PG&E Letter DCL-00-030

Docket No. 50-275, OL-DPR-80  
Docket No. 50-323, OL-DPR-82  
Diablo Canyon Units 1 and 2  
Response to NRC Reactor Systems Branch Questions Regarding WCAP-14707

**Responses to NRC Reactor Systems Branch Questions Regarding  
WCAP-14707**

Figure 1

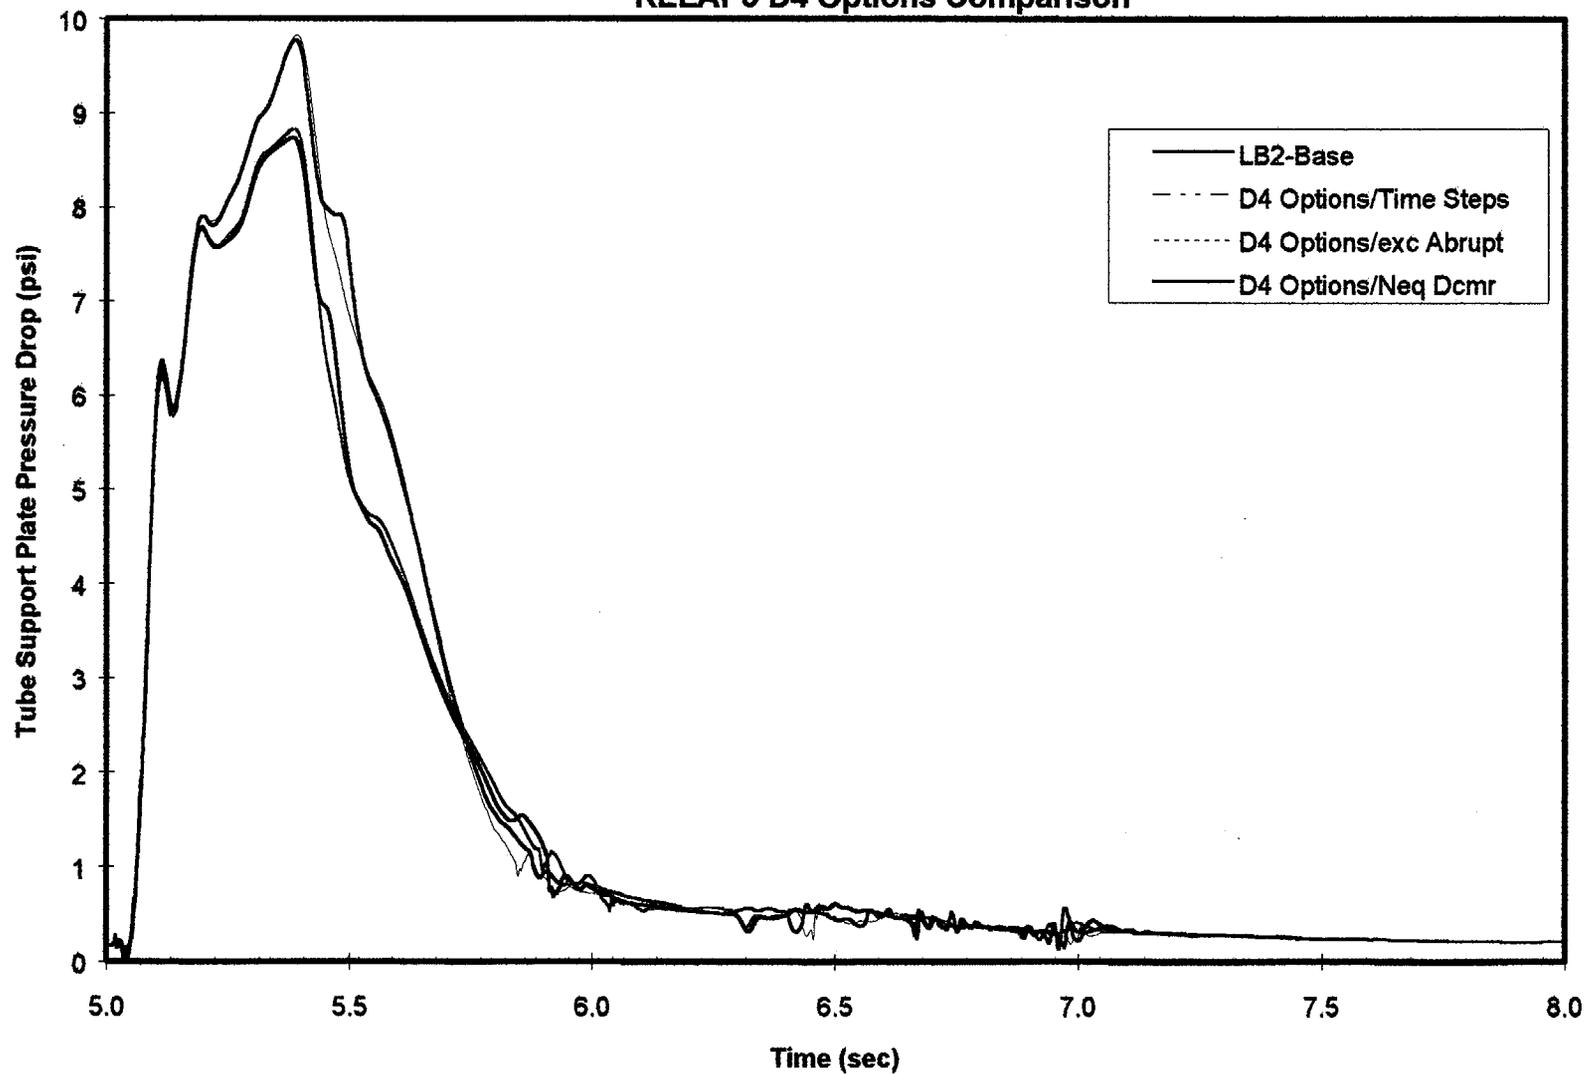
*Please provide a description of the dominant physical processes, the needed model capabilities, how the chosen tool meets these needs, and the inherent uncertainties in the chosen model.*

Figure 1 of this enclosure compares the original Model 51 pressure drop across the number seven tube support plate, with the results obtained with the revised model which implements the ComEd model options which were used for the D4 SG analysis. The results indicate that the characteristic response is not significantly changed, but the peak pressure is actually reduced for the D4 options case. In order to identify the source for the reduced peak pressure results, two additional sensitivity studies were performed. Since the ComEd analysis used longer time step intervals as summarized in Table 3 of this enclosure, the PG&E Model 51 SG was rerun using these time step values. The results plotted on Figure 1 show that this revision had an insignificant effect on the results. This is expected since the ComEd time step sensitivities in Reference 6 demonstrated that the time step size was appropriately small for the D4 analysis.

A second additional sensitivity case was performed using all of the D4 modeling options except for the restoration of the abrupt area change option, which was used in the original PG&E model as summarized in Table 2 of this enclosure. The abrupt area change is a RELAP5 option to model junctions with a significant change in cross section geometry such as valves and flow orifices. If not enabled, then RELAP5 calculates the pressure drop across the junction based on smooth geometry transition correlations. These results are also plotted on Figure 1 of this enclosure, and demonstrate that the D4 case with the abrupt area change option generated essentially the same peak pressure response as the original PG&E Model 51 SG analysis.

These results demonstrate that the SGTSP loads calculated by the original PG&E Model 51 SG RELAP5 model are not significantly affected by the slight differences in modeling options that were used in the Reference 6 analysis. In addition, the PG&E model predicts conservatively larger pressure drops with respect to the same conditions evaluated by the NRC approved ComEd model for the D4 SG.
